ADDENDUM NUMBER: 3
PROJECT: UNC Charlotte Residence Hall Phase XIV - Balance of Work

DATE: July 2, 2015
OWNER: UNC Charlotte
ARCHITECT: FWA Group

ADDENDUM NUMBER ONE (1)

PROJECT: Resident Hall Phase XIV
University of North Carolina at Charlotte
Building Package
SCO ID# 12-10117-03A
Code 41026 Item 307

A503

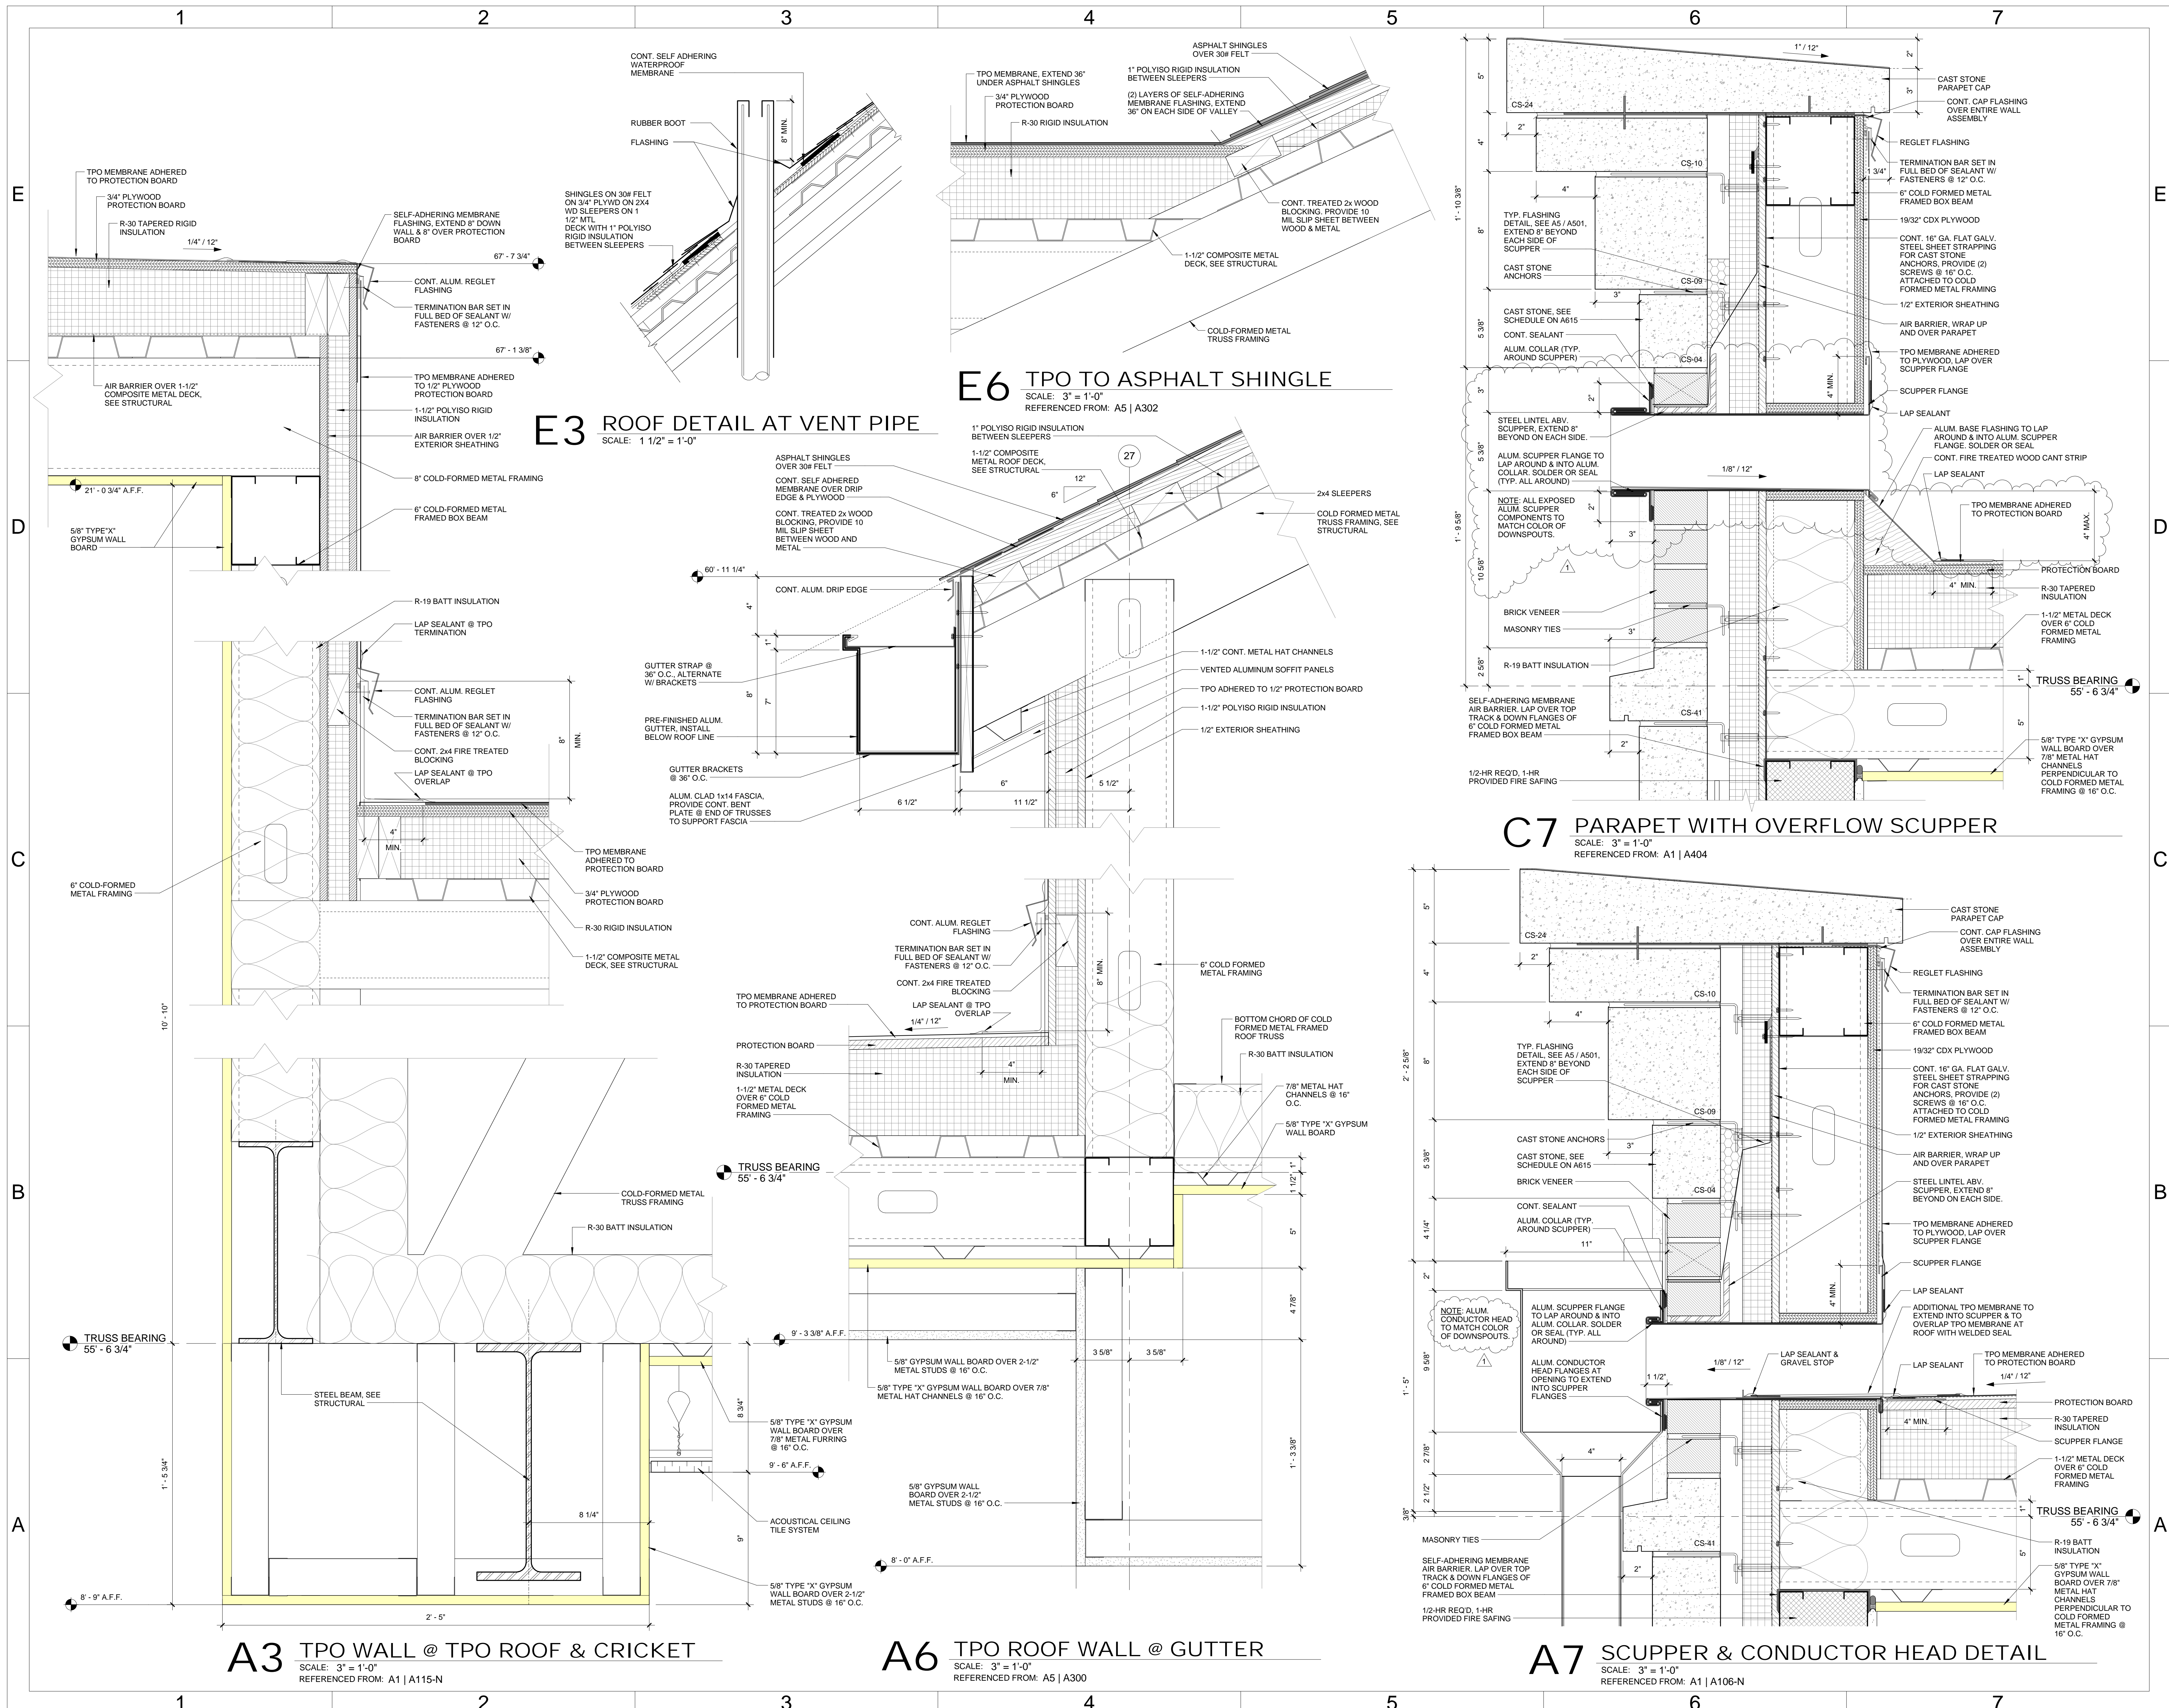
(Revisions include scupper/conductor head details, miscellaneous door schedule corrections, additional information for Window IF01 @ Laundry Rm's X42 and hollow metal frames revised to storefront @ Rm's 151, 157 & 159)

CF202-N

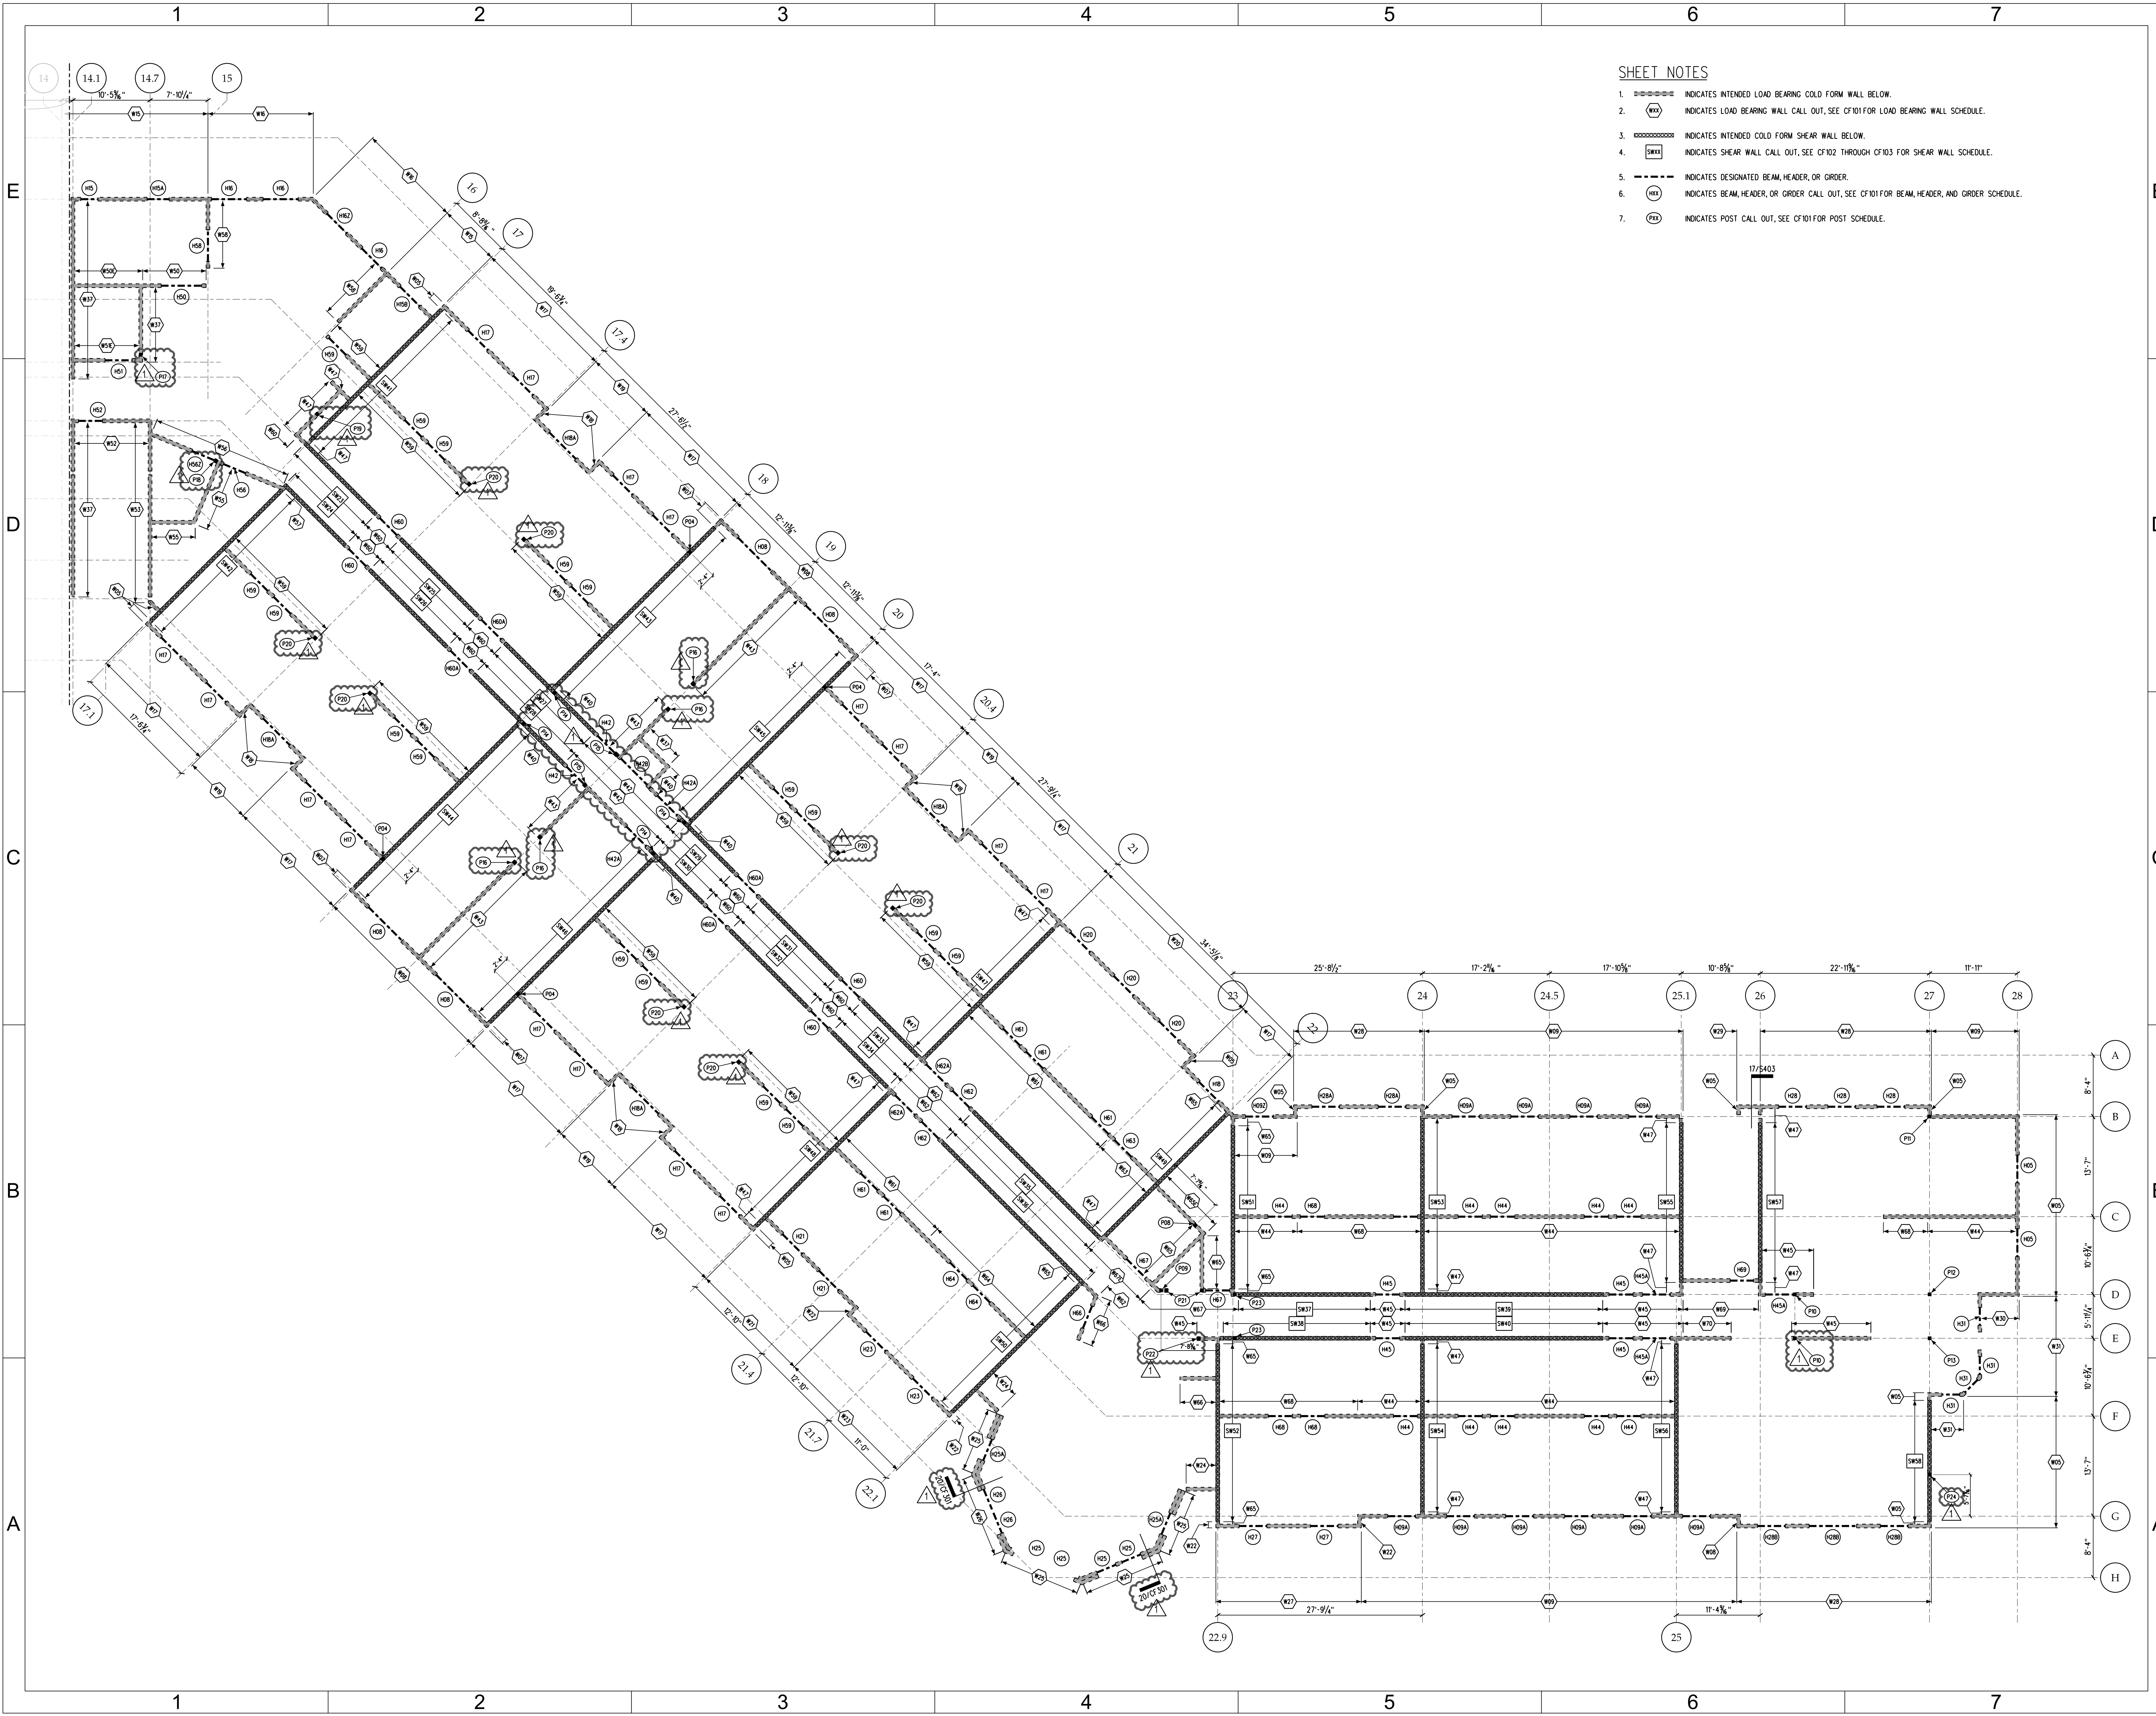
(Revisions include addition details & clarifications to cold-formed framing)
